SUNDRY NOTICES AND REPORTS ON WELLS
Do not use this form for proposals to drill or to re-enter an abandoned well. Use form 3160-3 (APD) for such proposals.

This is a bulk sundry request for 3 wells in Sand Dunes to modify the casing and cementing program.
The wells related to this bulk sundry are as follows:

Oxy USA Inc. – Sunrise MDP1 8-5 Federal Com 171H-173H
Bulk Sundry

PECOS DISTRICT DRILLING CONDITIONS OF APPROVAL

TMK UP DQX
Technical Data Sheet

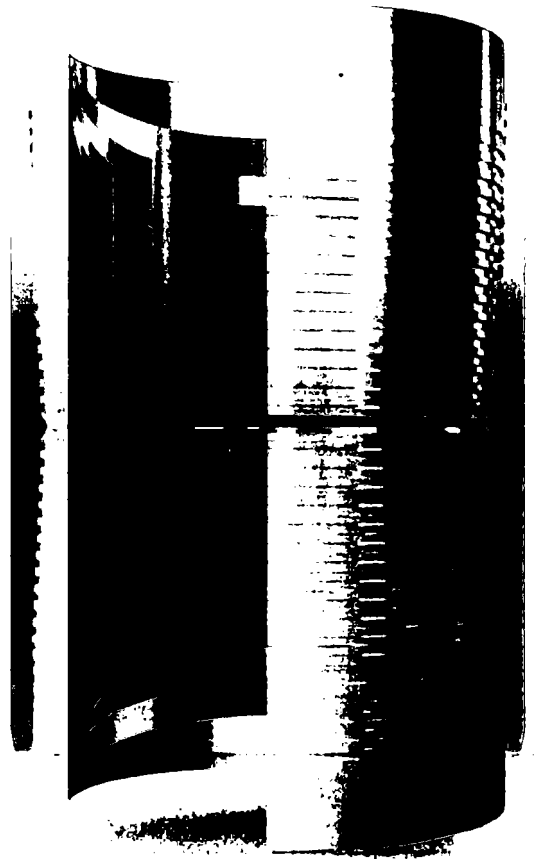
Oxy requests the option to run DQX or SF-Torque connections for the 5.5" 20# P-110 production casing string.
